MIAMI-DADE COUNTY
DEPARTMENT OF TRANSPORTATION AND PUBLIC WORKS (DTPW)

ADDENDUM NO. 3
October 29, 2021

PROJECT: Roadway Improvements to NW 37th Avenue from NW 36th Street to NW 79th Street Project No. 20210093

Revised Typical Section Plans Sheet No. 3 for addendum No. 3

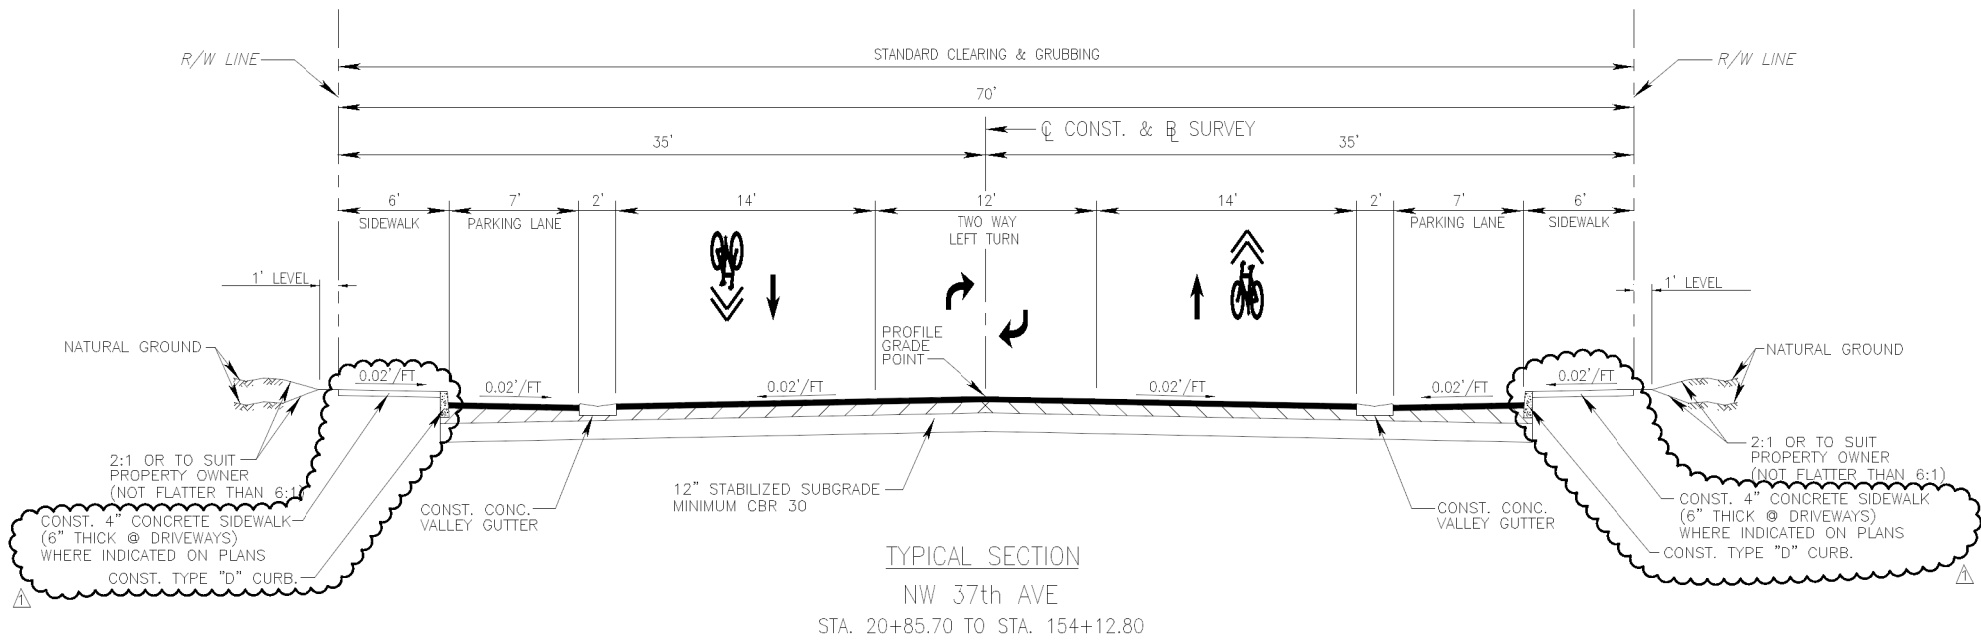
1. Delete sheet No. 3, Typical Section, in its entirety, and replace with attached Revised Typical Section Plans Sheet No. 3 for addendum No. 3.
2. Delete sheet No. 264, Summary of Quantities, in its entirety, and replace with attached Revised Lighting Tabulation of Quantities Sheet No. 264 for addendum No. 3.

DATE	BY	DESCRIPTION	DATE	BY	DESCRIPTION
10/15/21	E.S.	REVISED TO TYPE D CURB

DATE: 03/03/2021	SCALE: AS SHOWN
SHEET P-69 OF 171	
DWG. No.

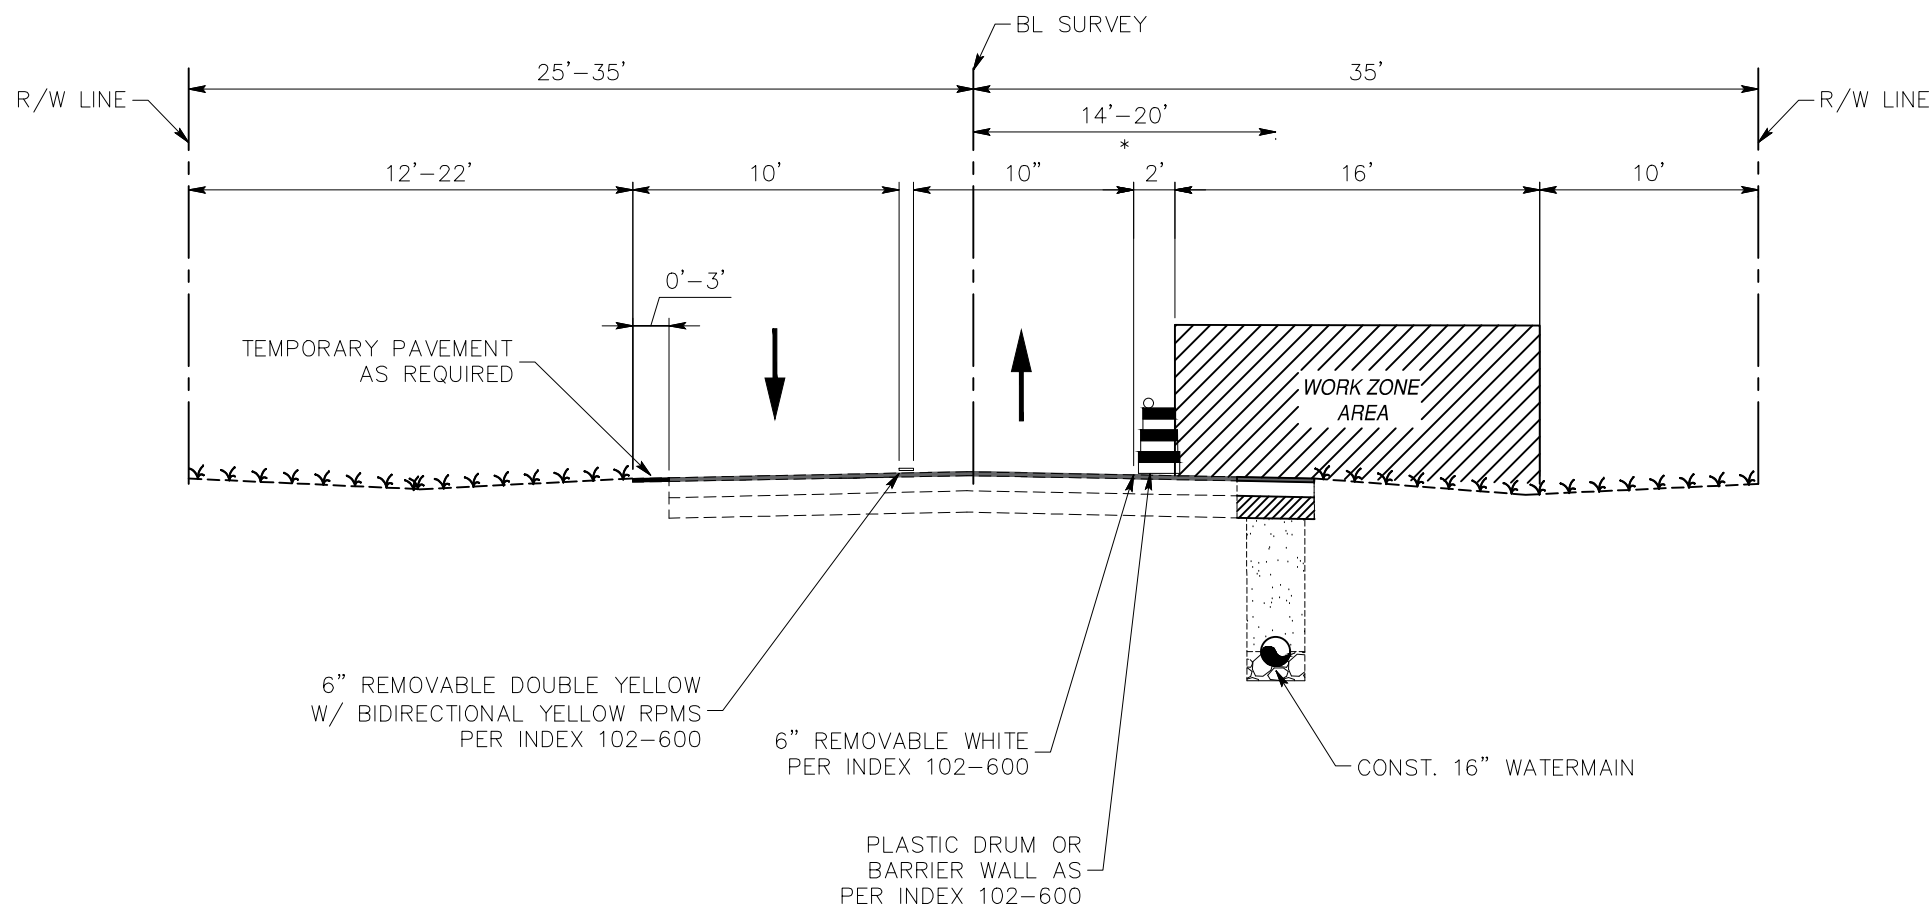
1. Delete sheet No. 69, Typical Section, in its entirety, and replace with Revised P-69 Water Main for Addendum No. 3.

No.	DESCRIPTION	DATE	BY
△ 1	REVISION #1	10/21/21	D.O.

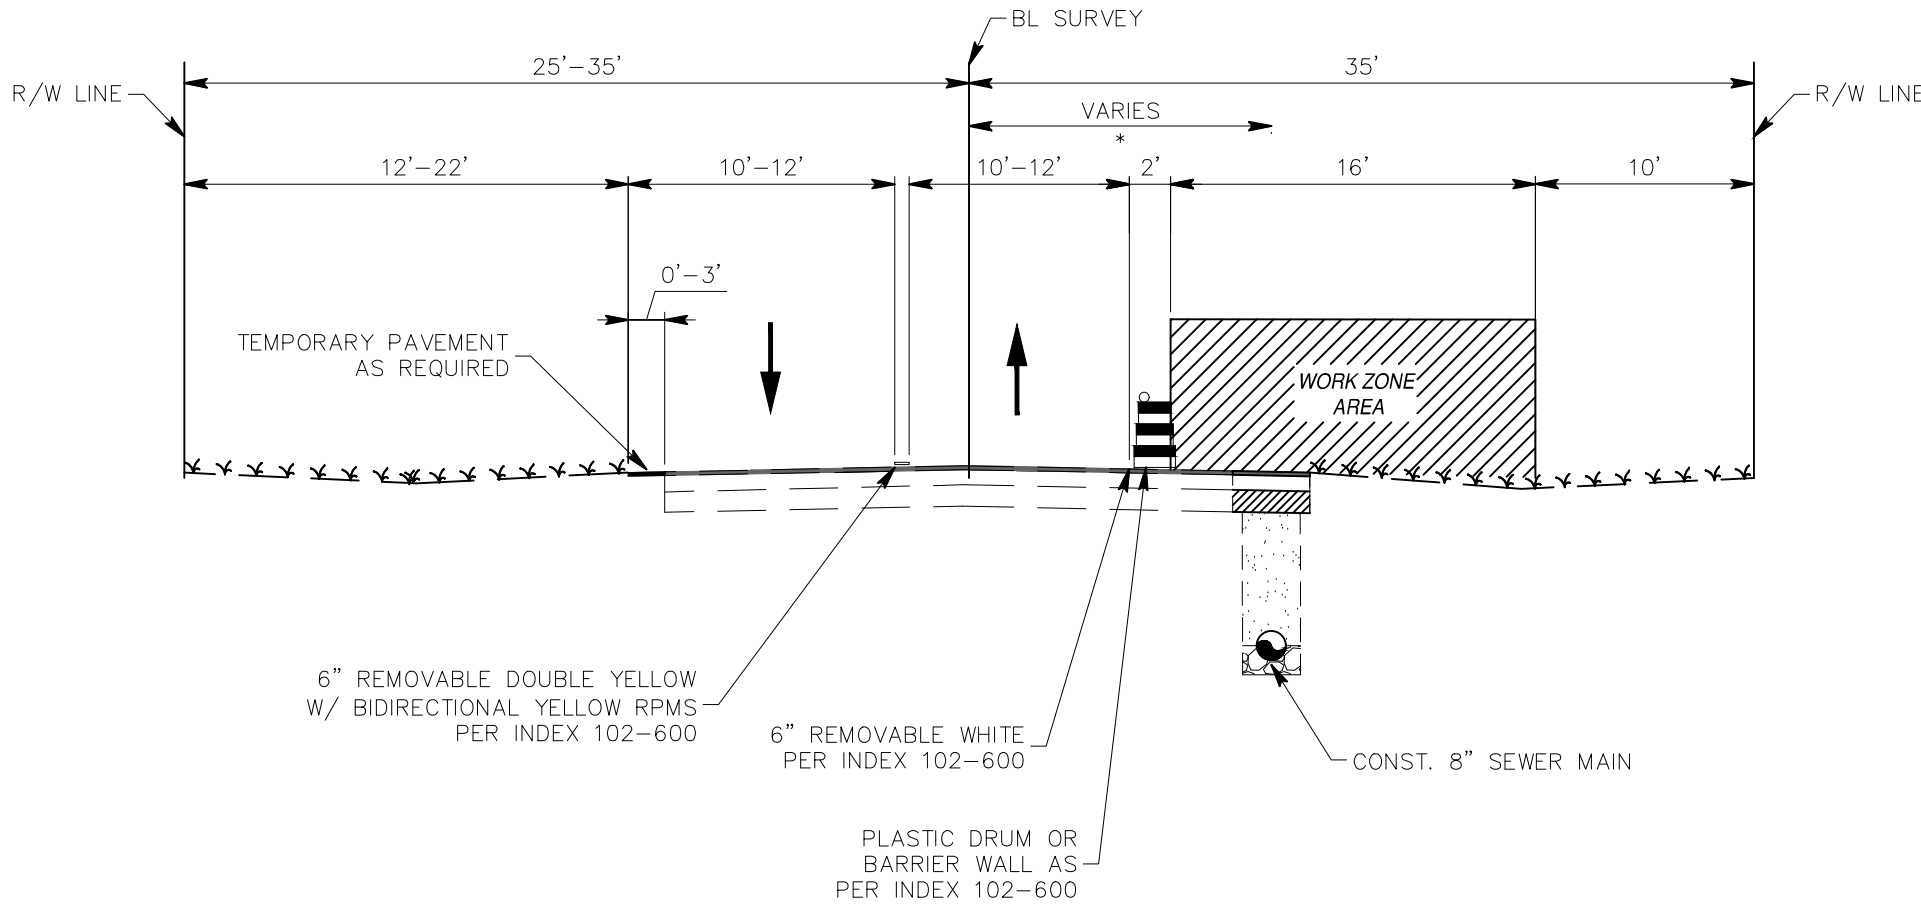
1. Delete sheet No. 47, Typical Section, in its entirety, and replace with Revised P-47 Sanitary Sewer for Addendum No. 3.
